Keri Keri Wind Farm – Response to Submissions (TfNSW)

Amber Organisation has been engaged to assist with response to agency advice received from Transport for NSW (dated 11 March 2026) related to Keri Keri Wind Farm. Table 1 provides a summary of the comments which have been addressed herein.

Table 1: TfNSW Response to Submissions

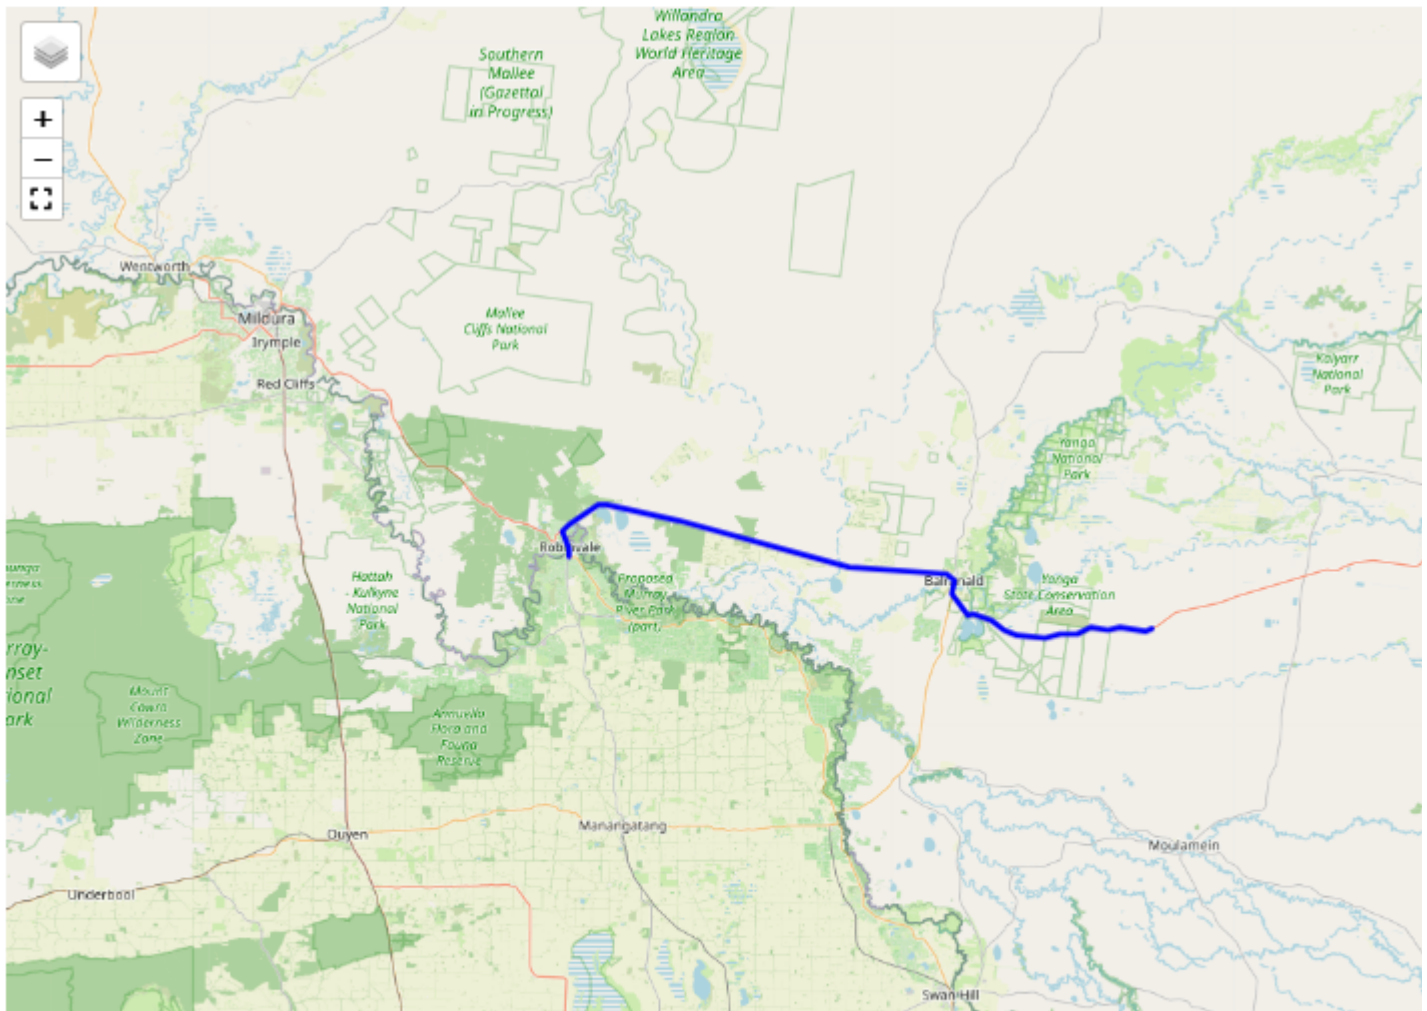
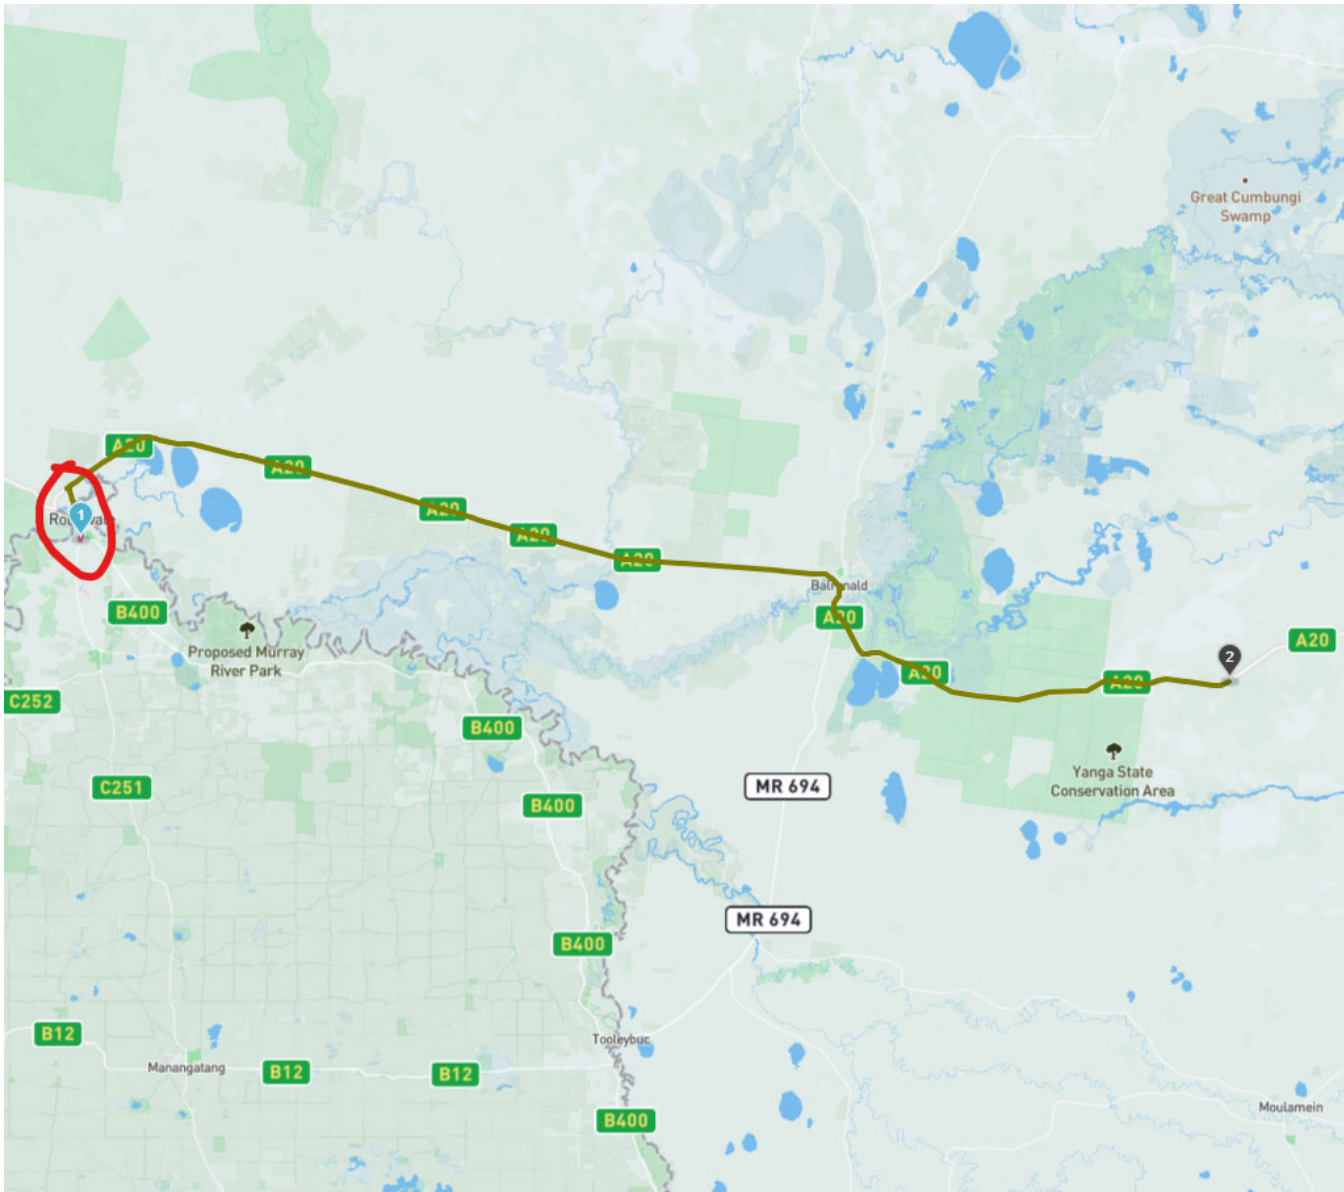
The Euston Route (2QETS-1) includes an additional section of Murray Valley Highway – could you please clarify if this is also suitable, noting there is a bridge over the Murray River?

This route is also suitable as per below.
